**Re: Fremont Apartment Project Design Revisions**

# fremont place

2018-04-11  
proposed design revisions

revised section at greenway  
showing a total of 17'-6" of additional  
width from proposed design changes

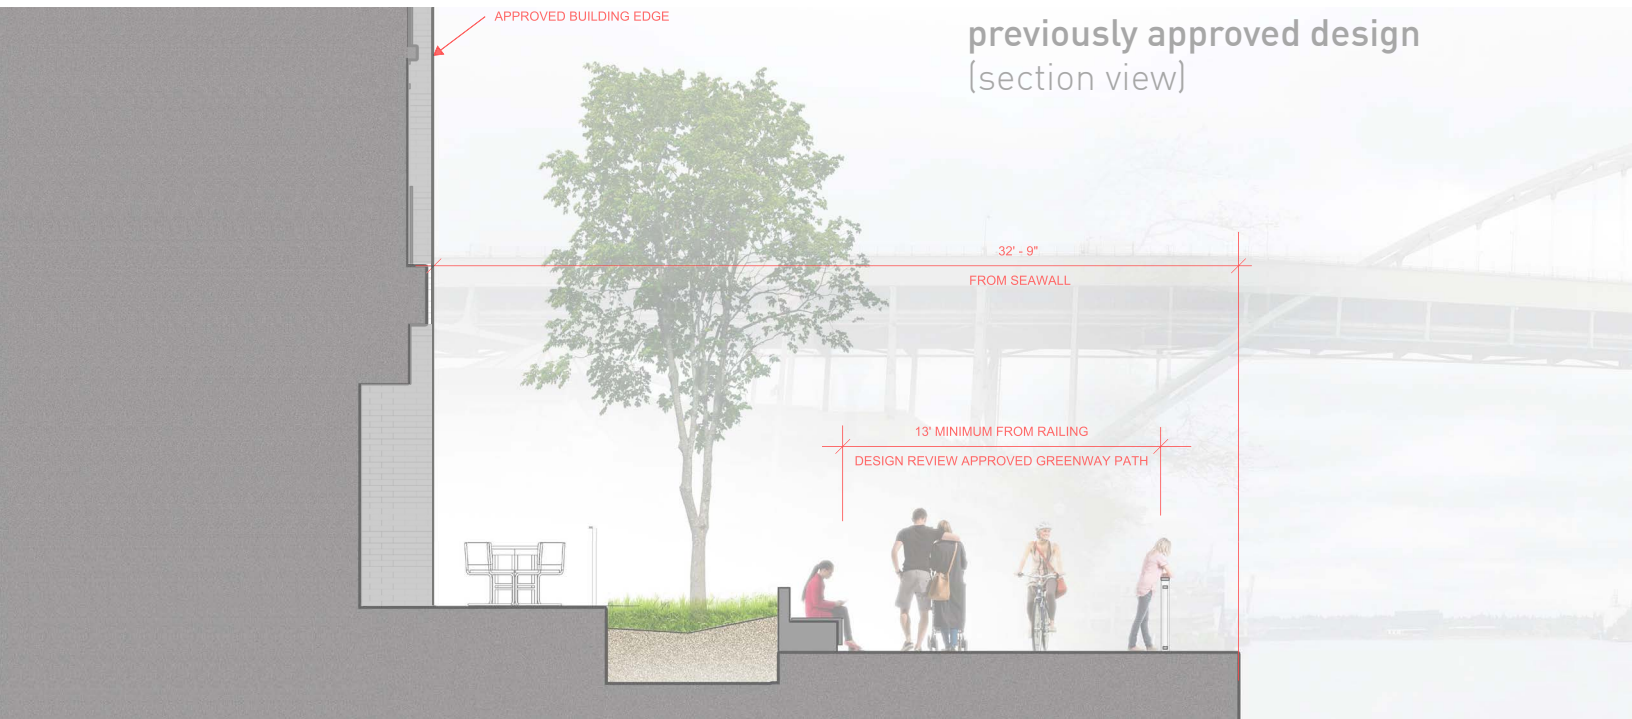
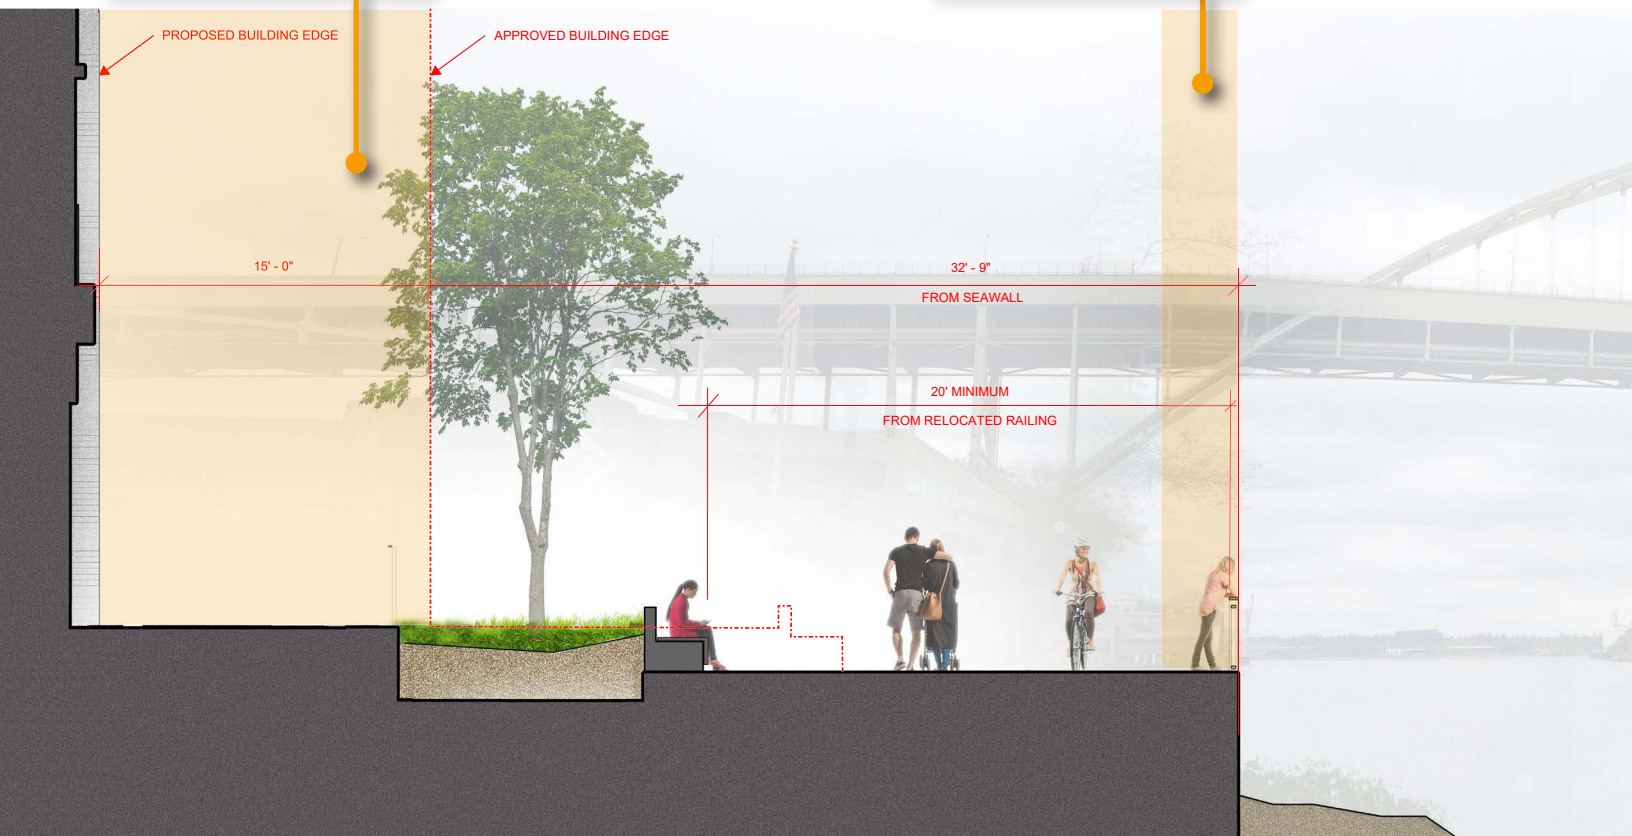
distance from the building to the seawall

**17'-6"**

additional width provided by modified design

**43'-4"**

additional useable  
public space at  
relocated guardrail

# greenway path width

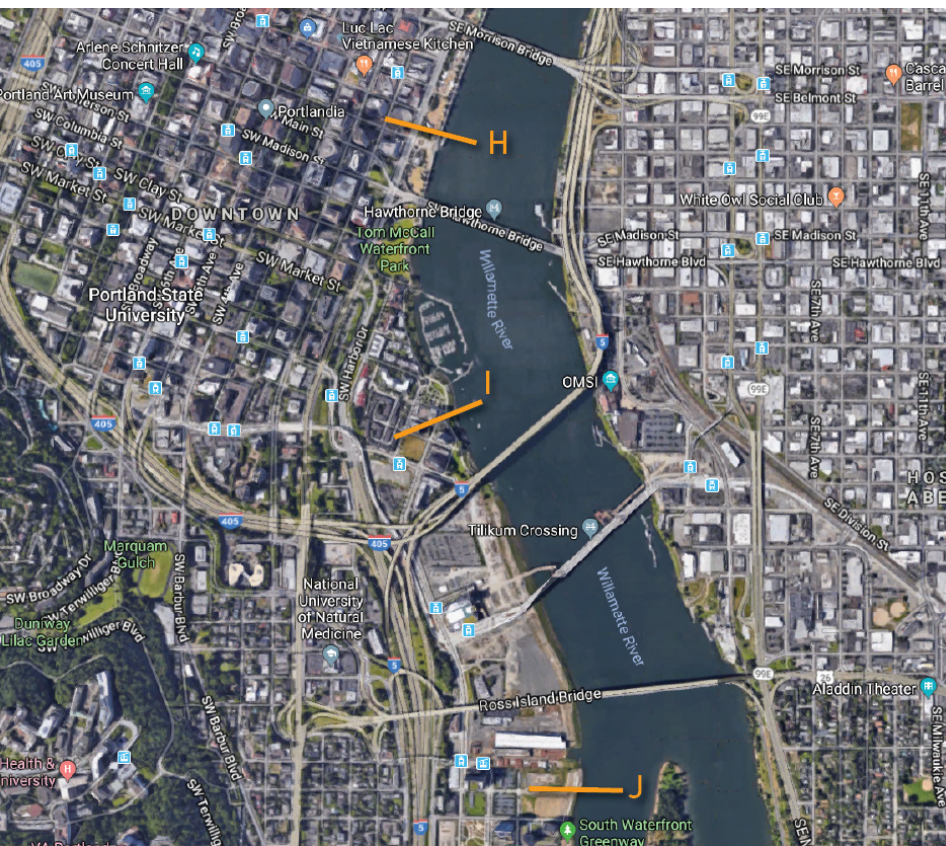
at 20', the proposed width for the primary path at fremont place will be wider than any section of the greenway path from south waterfront to terminal one.

**FP: fremont place = 20'-0"**

# bike storage reconfiguration: bike racks meet code standard 2'x6'

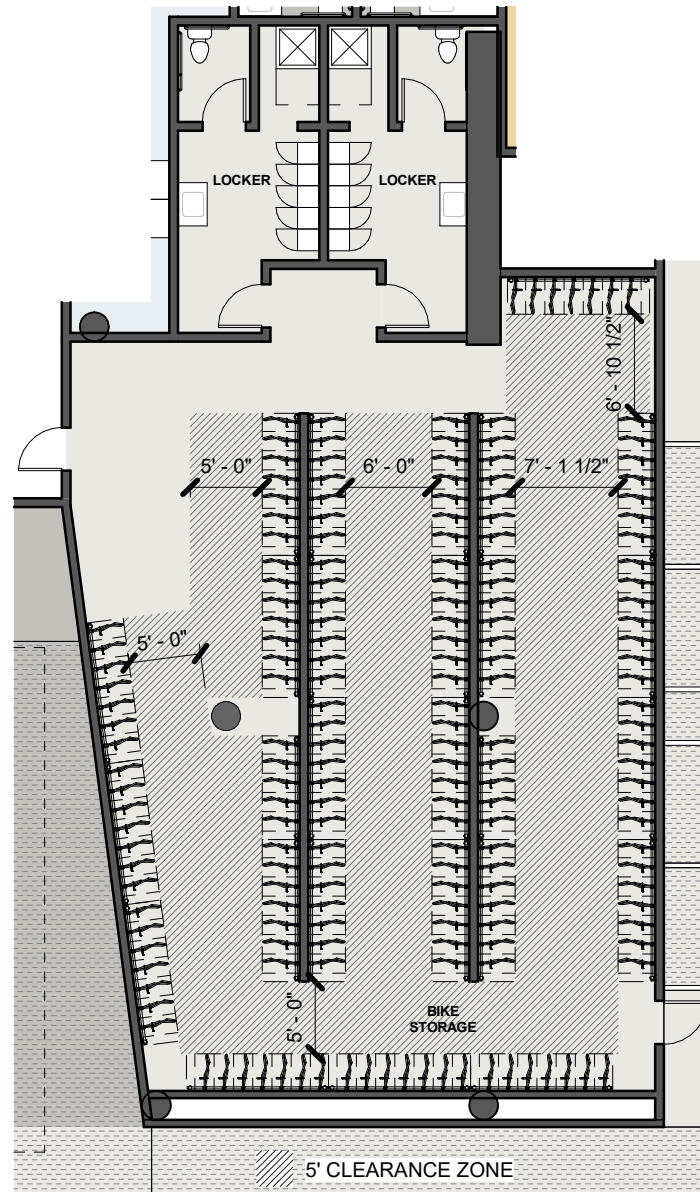
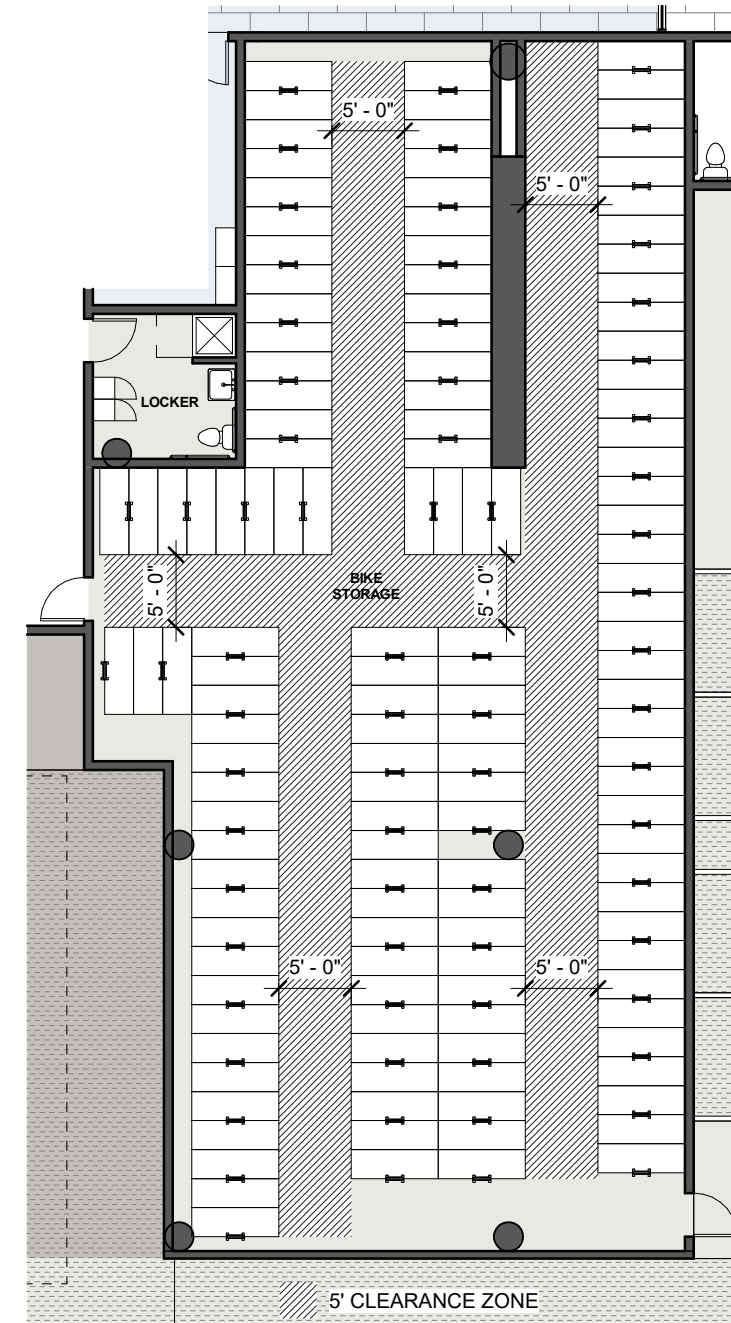
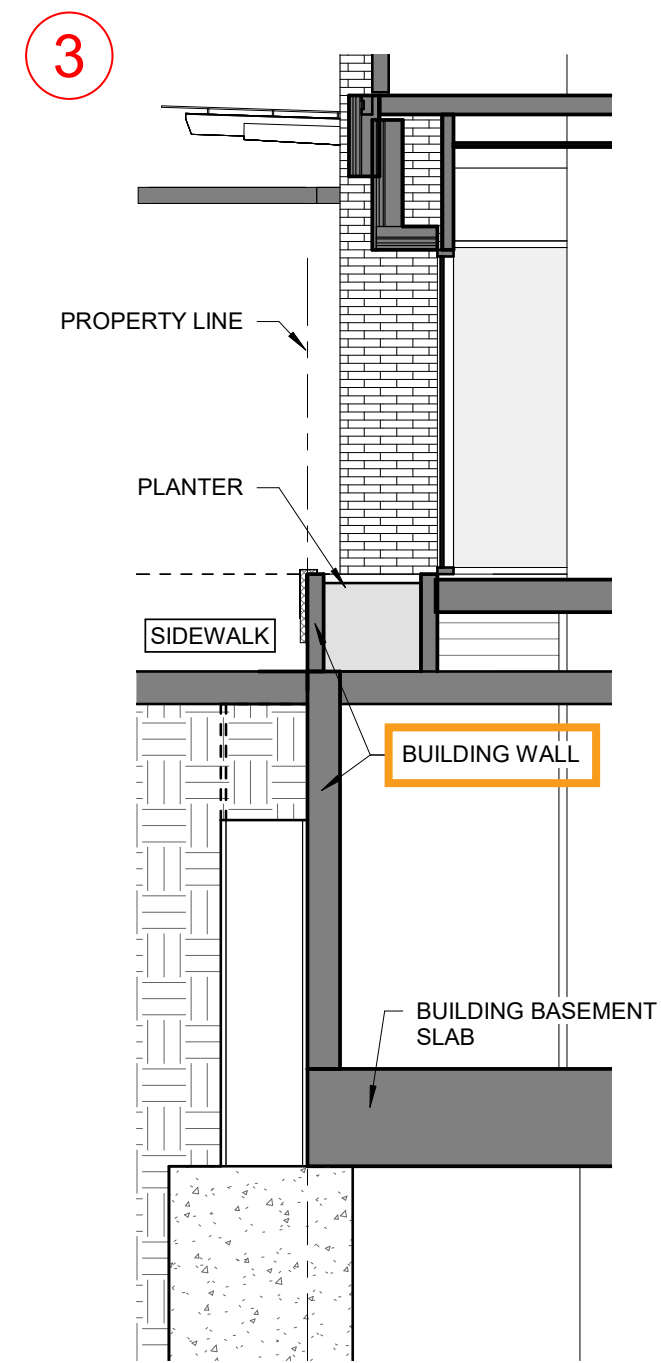
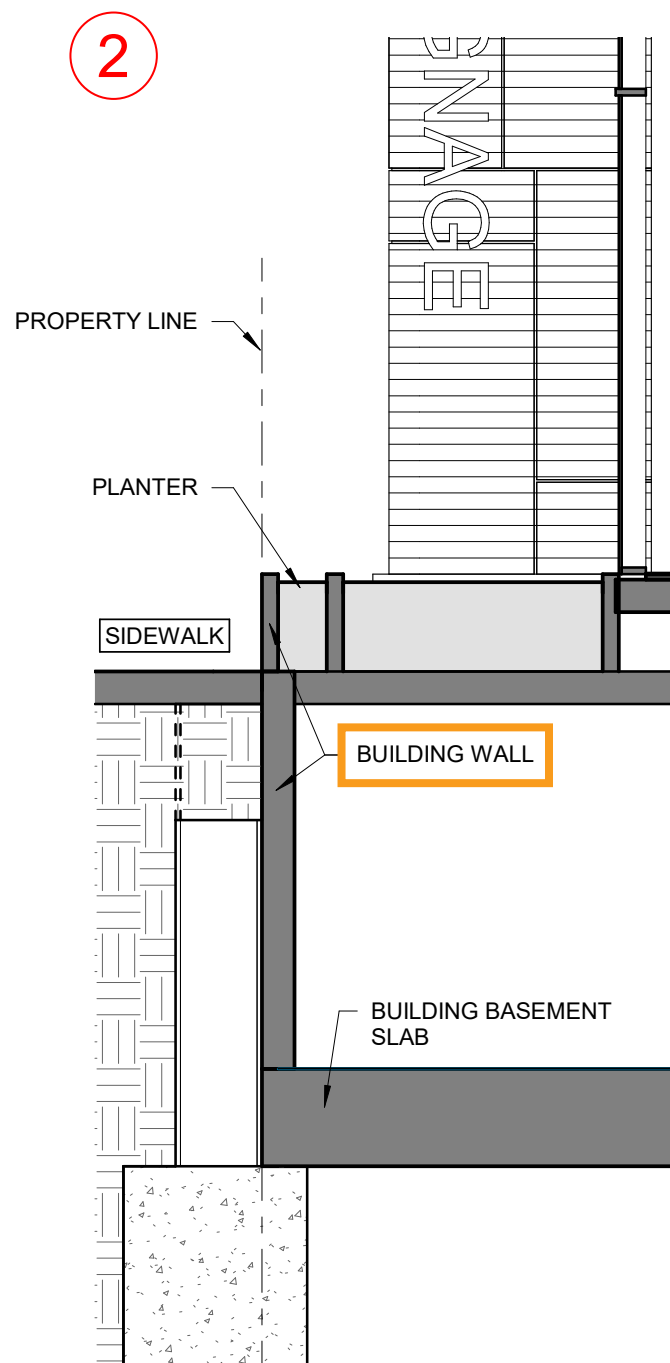
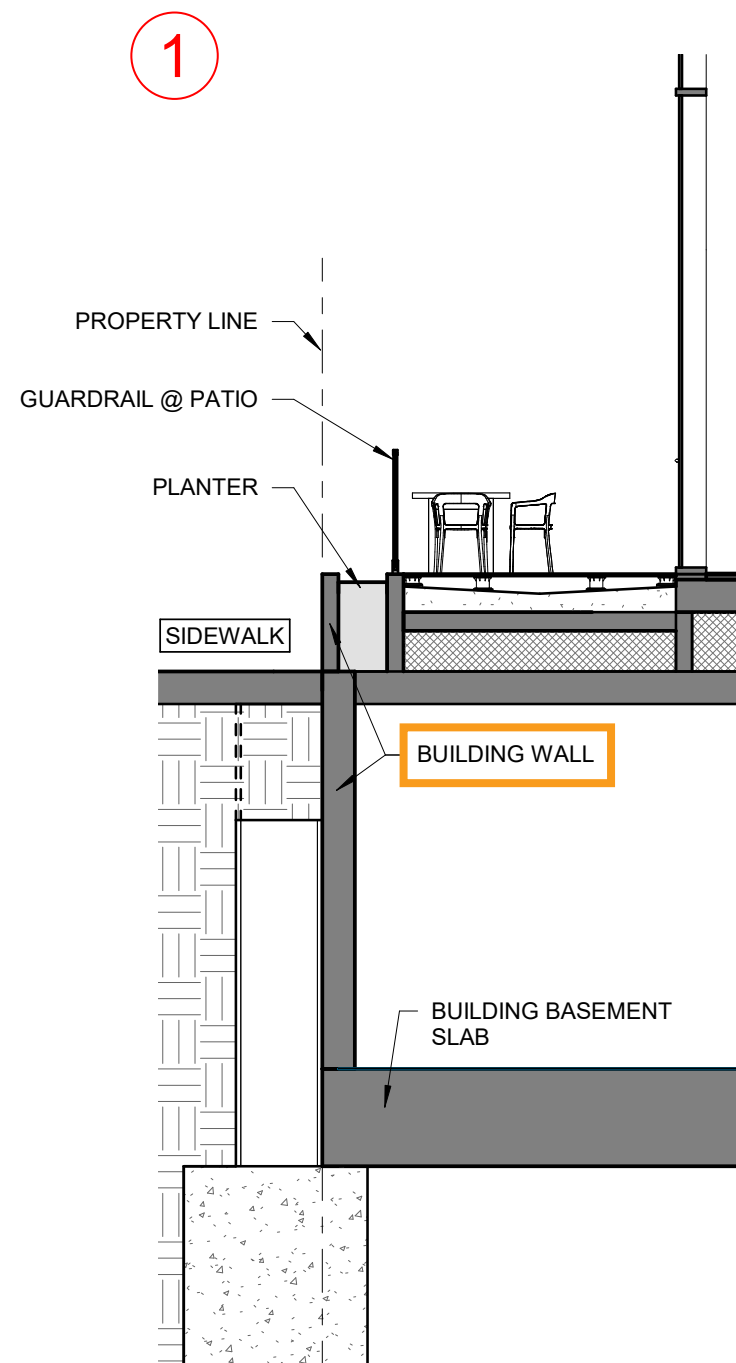
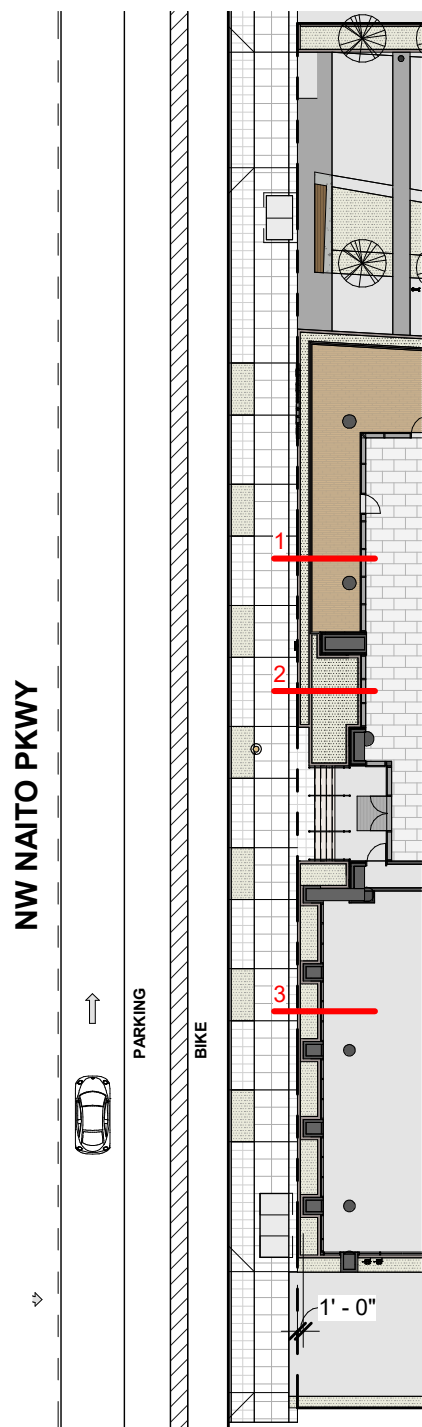
approved  
(206 BIKES)

proposed  
(140 BIKES)

**TOTAL PROVIDED = 275 IN UNITS + 140 IN BIKE STORAGE  
= 415 SPACES @ 2' X 6' SIZE**
